5.3 Department of Primary Industries and Resources

Issues identified by the Department of Primary Industries and Resources are provided in Table 5-32. A response to each issue is provided in Section 5.3.1 through Section 5.3.81.

Table 5-32 Issues identified by the Department of Primary Industries and Resources

Figure 5-74. Amended figure 4-3 from the draft EIS (Environmental impact assessment process (NT EPA))

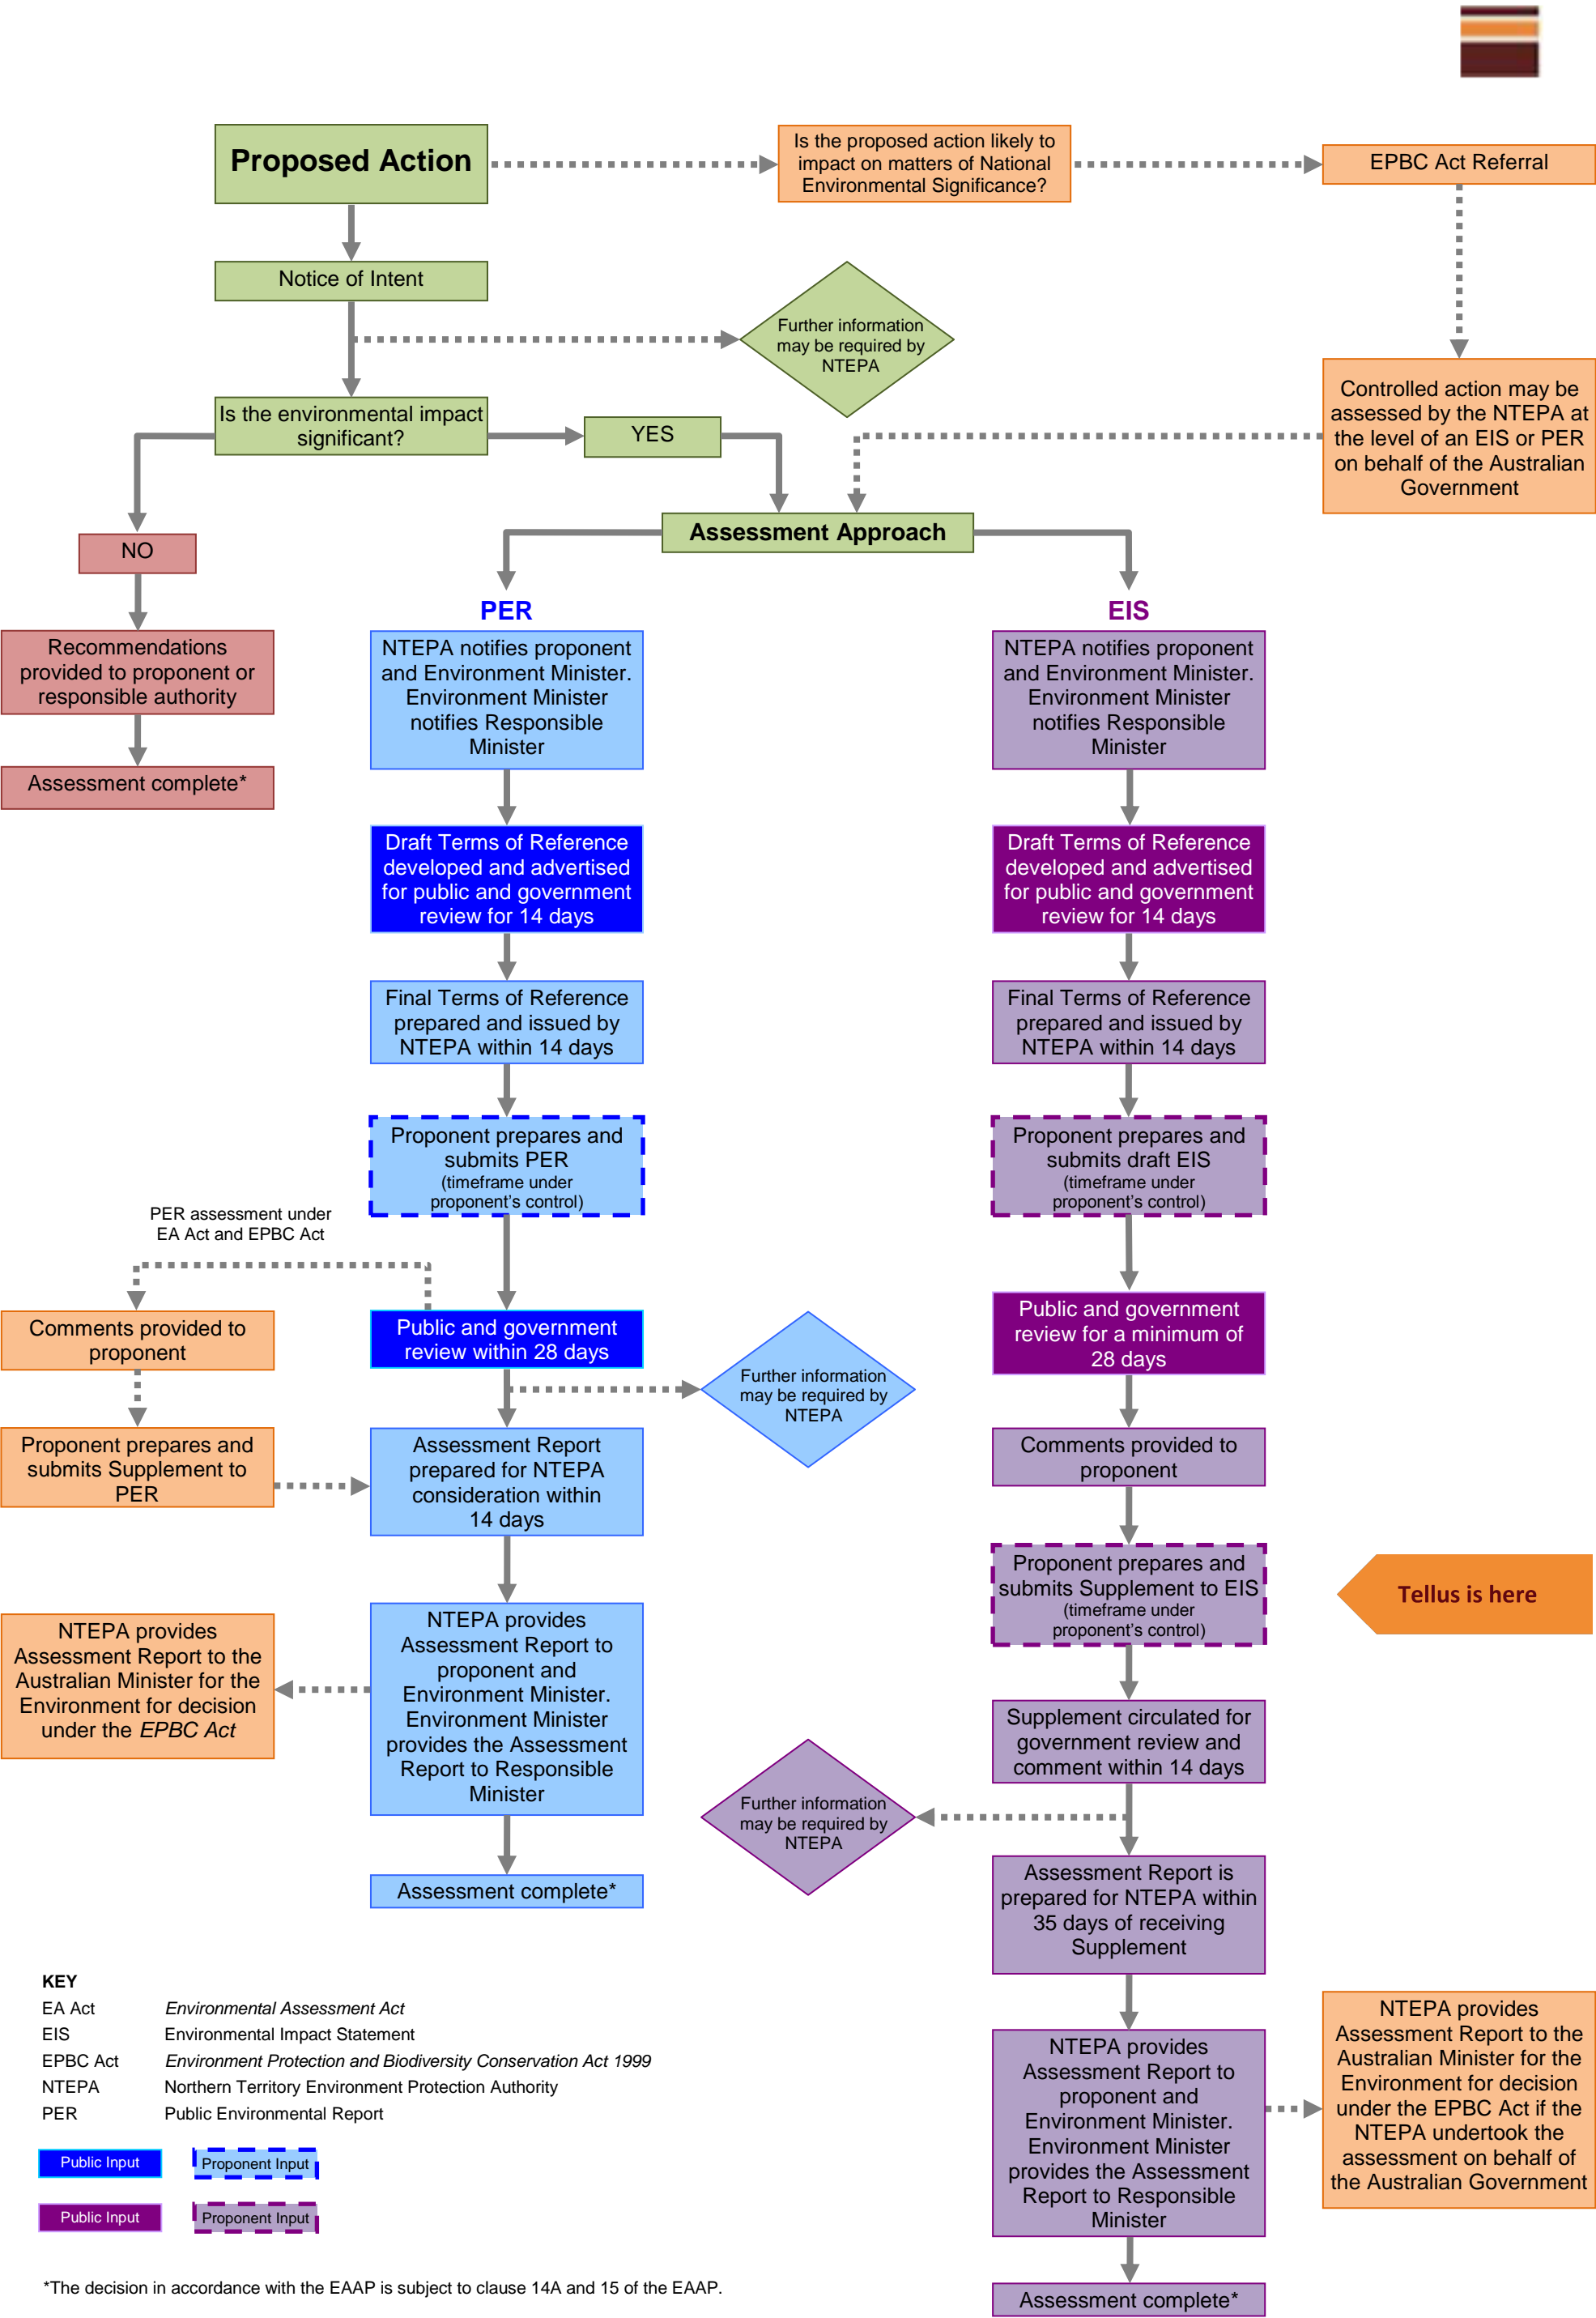
Figure 4-3 Environmental impact assessment process (NT EPA)

This figure is illegible.

Noted. Please refer to Figure 5-74 (amended Figure 4-3 of the draft EIS).

Figure 5-75 Likely groundwater drawdown related to operations for the Chandler Facility

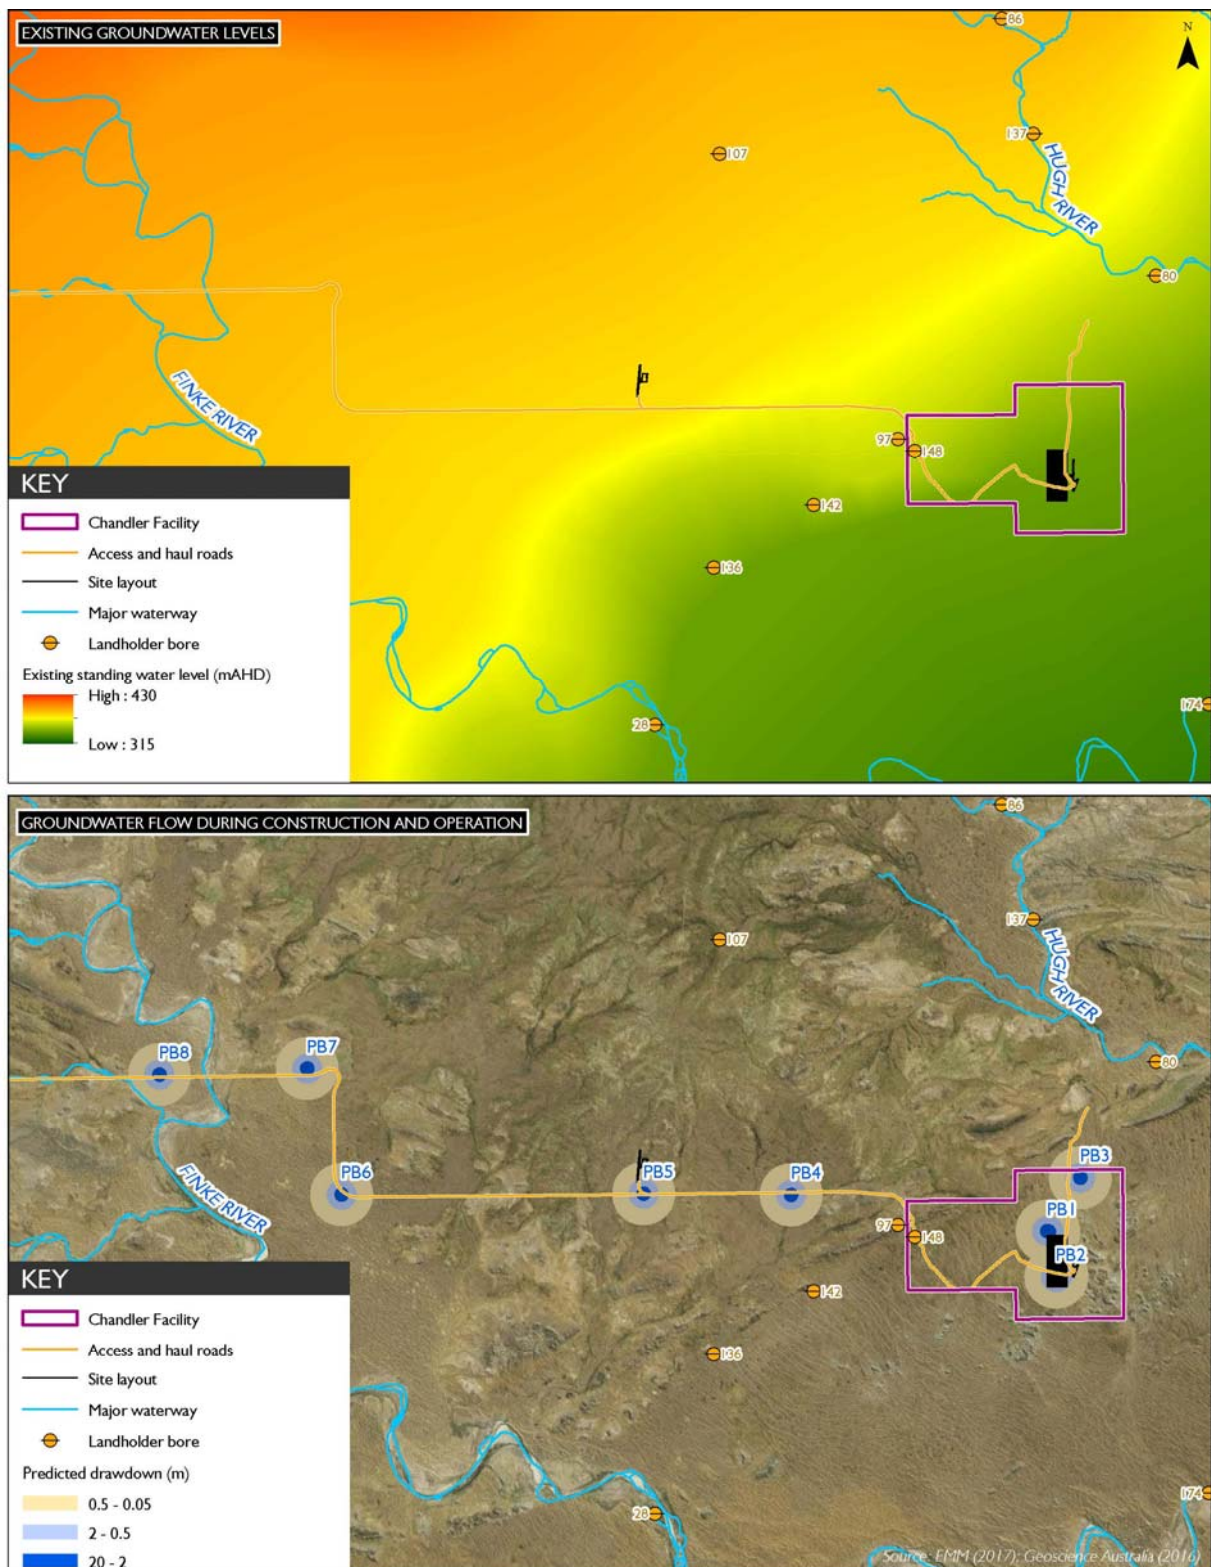
A figure that shows the expected extent of drawdown in contours for the life of mine (LoM) operation, should be included. While LoM is never certain, the potential maximum times should be outlined. While Appendix P contains a simplified version of this, a more detailed version, which includes a contour overlay of the mine area, is required.

A conceptualised groundwater drawdown contour map has been developed (refer to Figure 5-75). As discussed in Section 8.4 of the draft EIS, drawdown has been calculated using the De Glee (1930) analytical model of steady state drawdown in leaky aquifer systems.

A figure showing the cumulative extent of project-related groundwater drawdown relative to the project area, key sensitive environmental and human users (i.e. GDEs, landholder bores, Hugh River and Finke River) has been prepared (refer to Figure 5-75).

Figure 5-76 Rainfall data recorded at Chandler AWS between November 2015 and June 2017

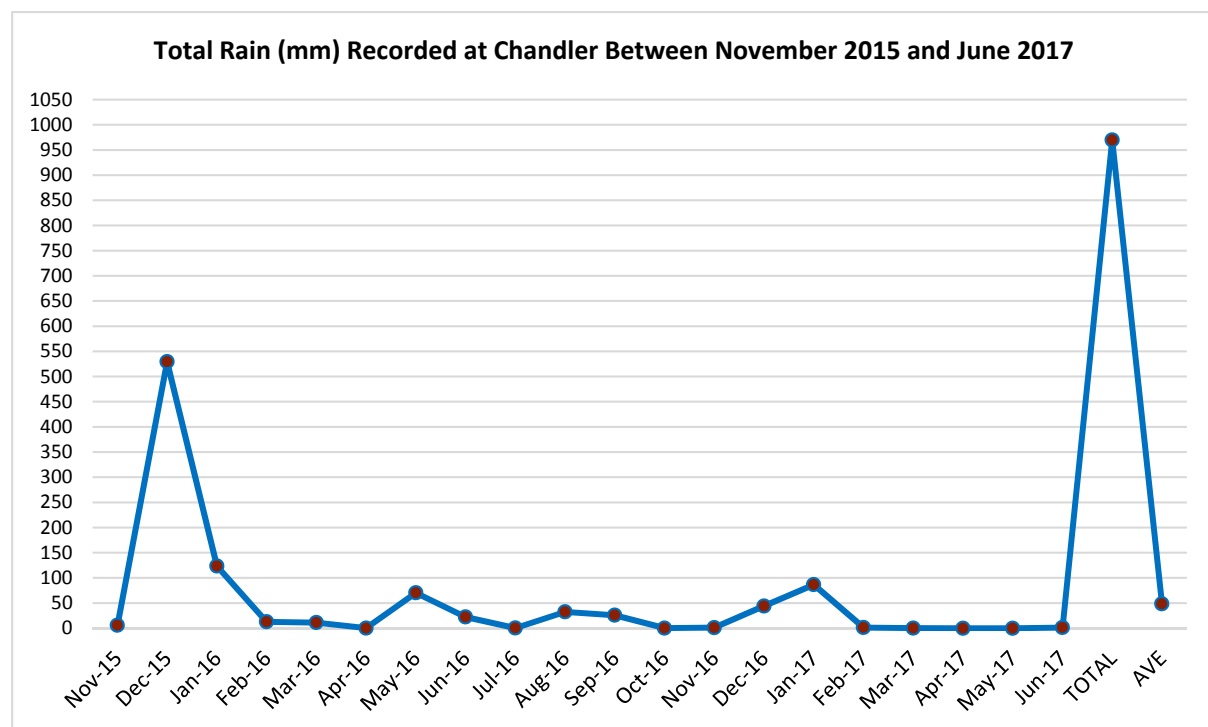
Please provide more detailed information e.g. location and size of water storage areas and rainfall data.

The proponent installed an Automated Weather Station in November 2015. Since then, daily records of rainfall have been recorded. A summary of that data is included in Figure 5-76. The highest rainfall recorded in any one month was 529.4 mm in December 2015 which is an anomaly when compared to the remaining 19 months of data. The lowest recorded rainfall to date has been shared between April and May in 2017 with 0 mm. The wettest months on average to date belong to December and January. Total rainfall recorded over a 20 month period is 969.8 mm which is an average of 48.5 mm a month. The proponent will continue to monitor rainfall data to inform future flood modelling that will be undertaken during the BFS.

Figure 5-81 Annual and seasonal wind roses at Chandler – 5 November 2015 to 30 June 2017

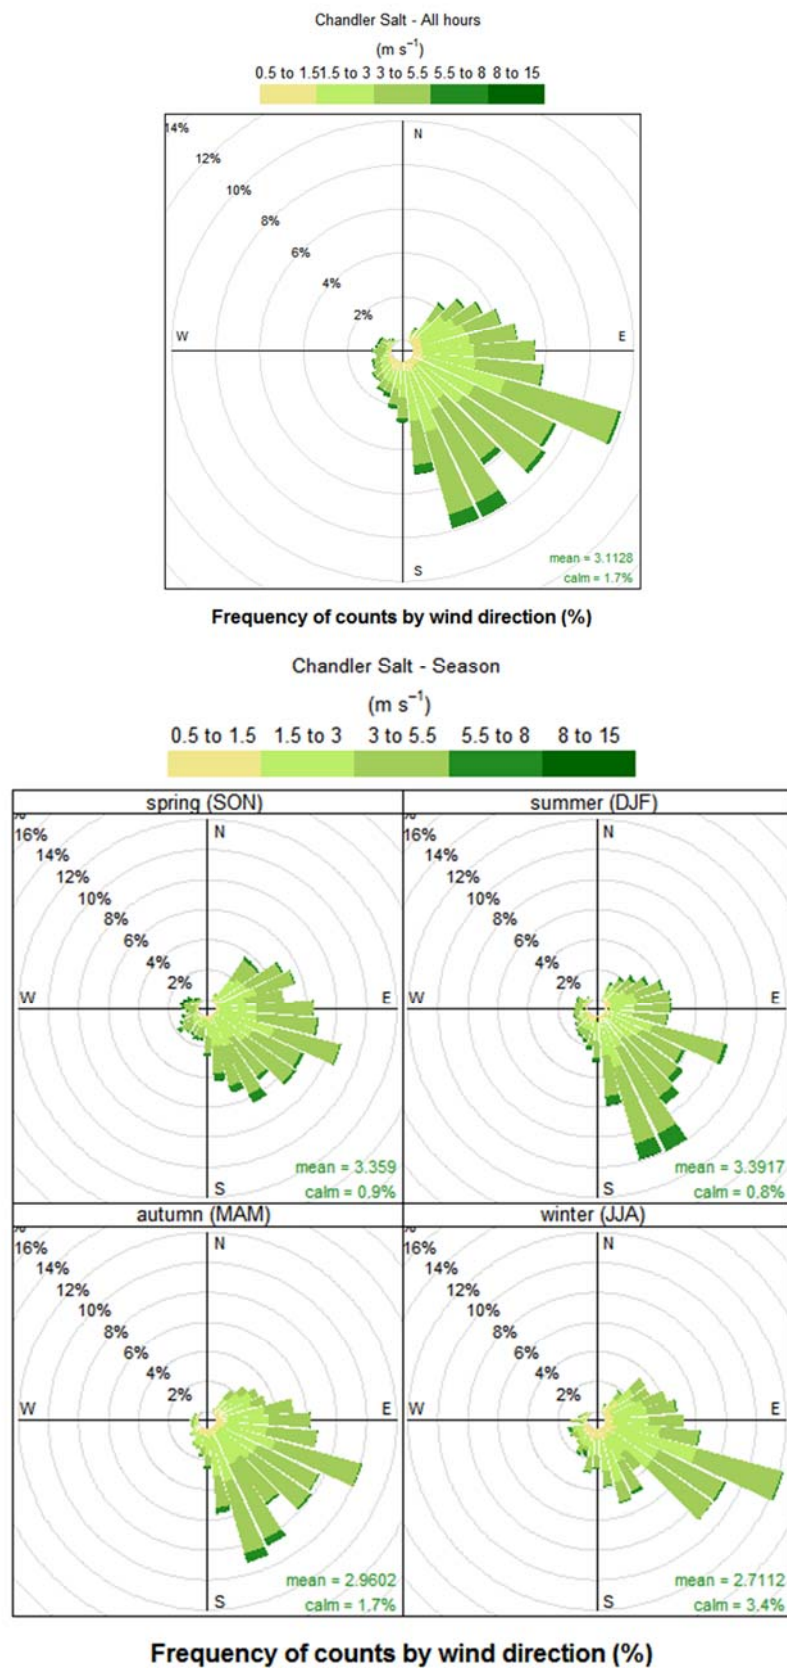
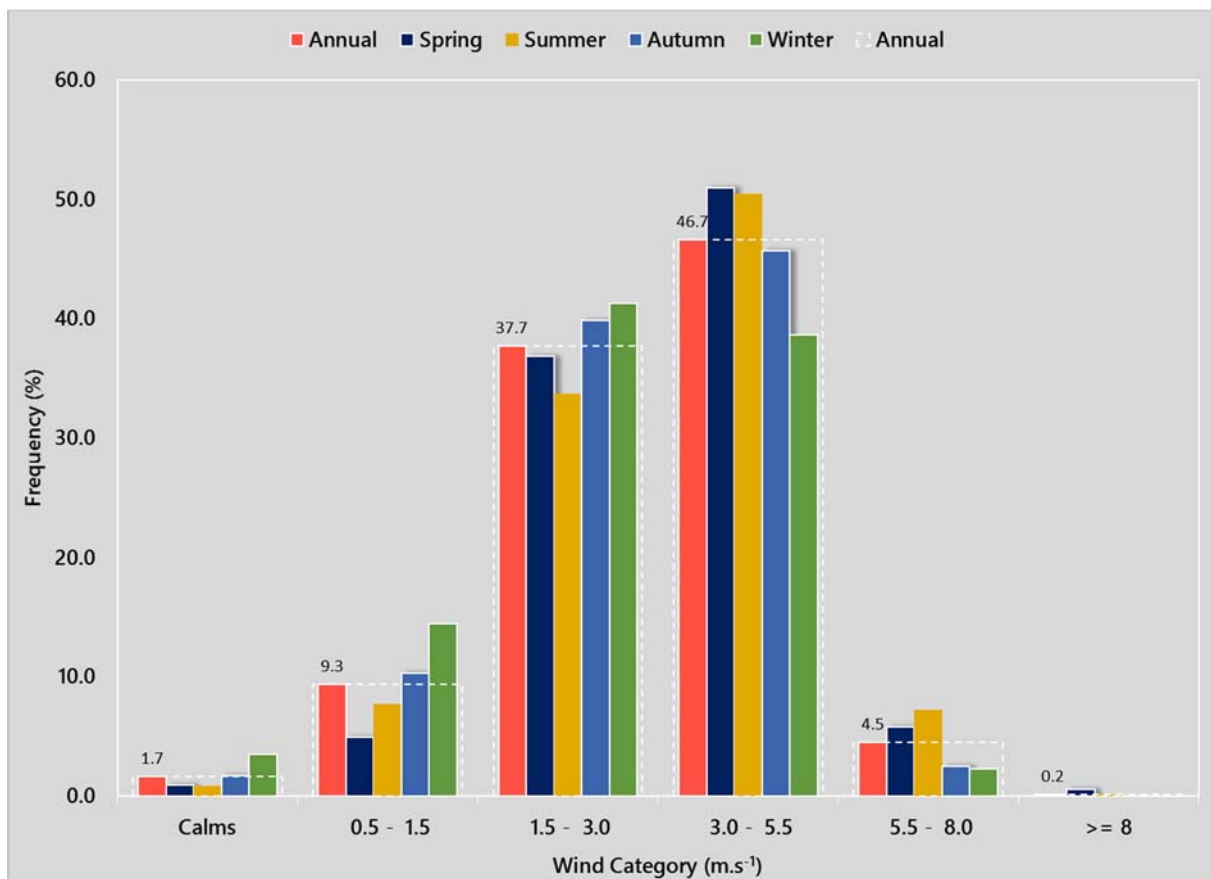
The prevailing wind directions should be shown on Figure 15-1.

Annual and seasonal wind roses for the Proposal site are presented in Figure 5-81. The distribution of wind speed in a number of categories, including calm winds are presented in Figure 5-82

Figure 5-86

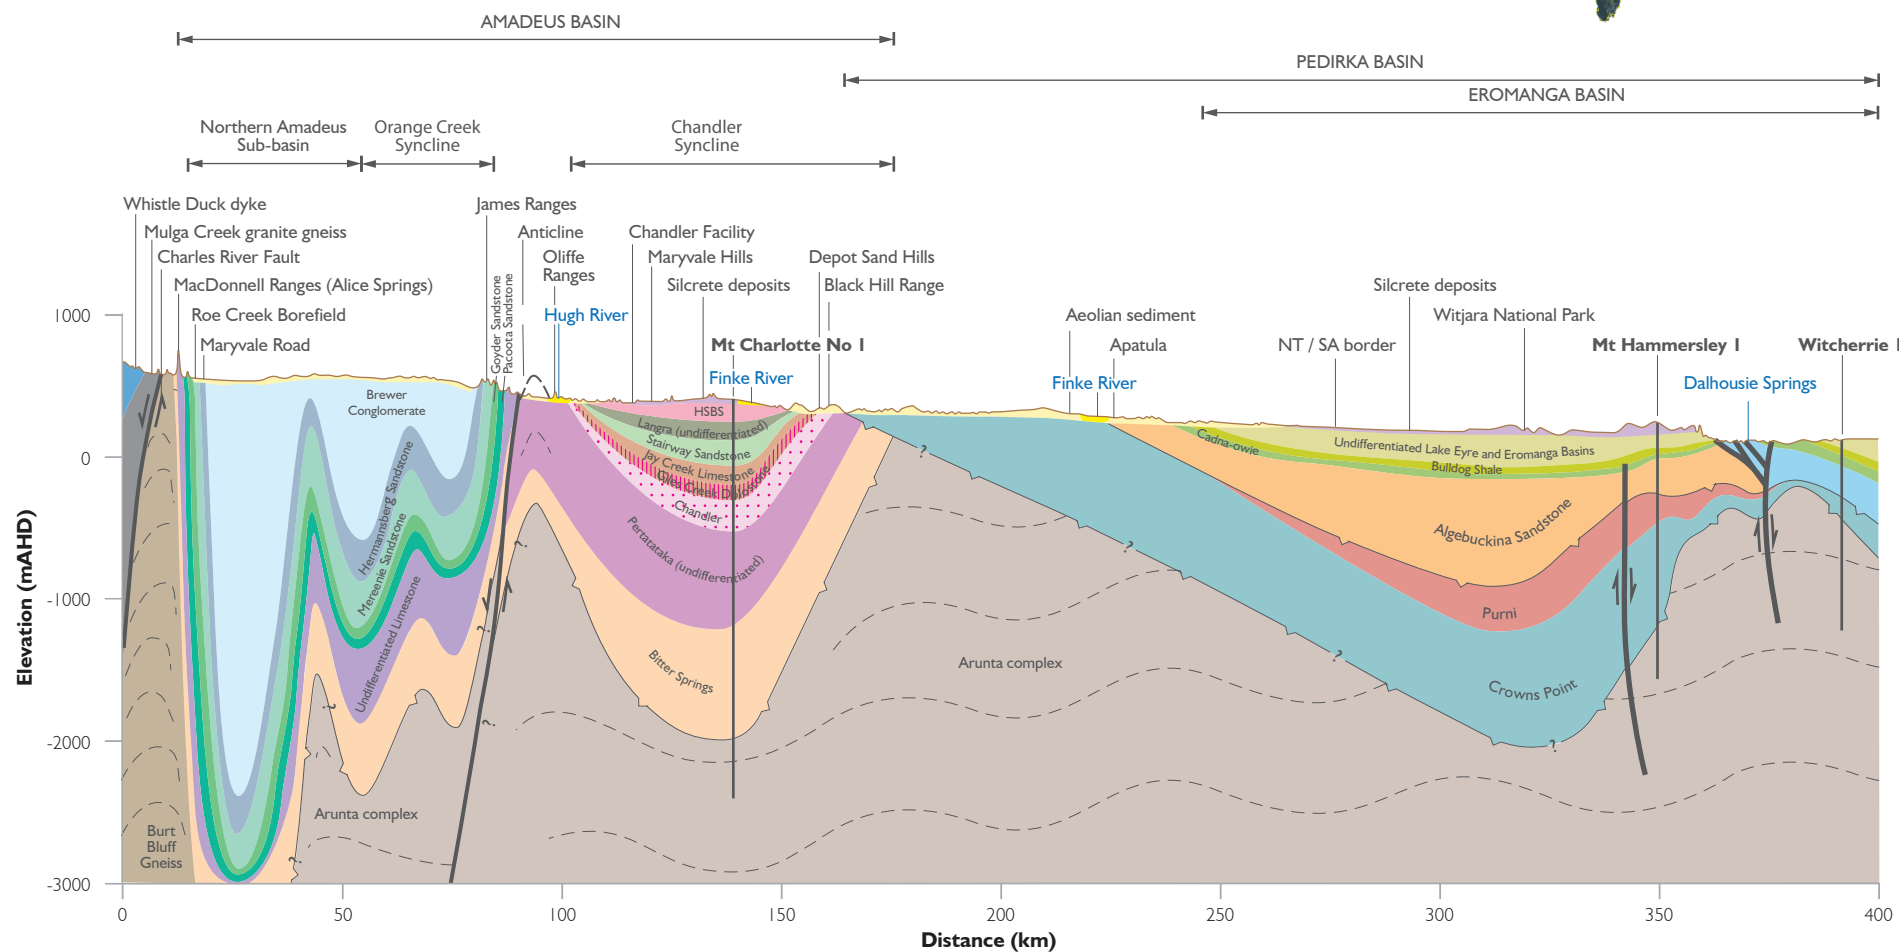
Groundwater - There is confusion in the report in relation to cross sections discussing groundwater systems. Cross section transect labelled F-F¹ in Figure 8.13 in Report Part II is labelled as D-D¹ in the diagram on the following page (p8-388). The same figure presented as 8.2 in appendices P-Q shows the cross sections labelled with section E in a different orientation and the second cross section labelled D-D¹.

An updated regional cross section is provided in Figure 5-86.
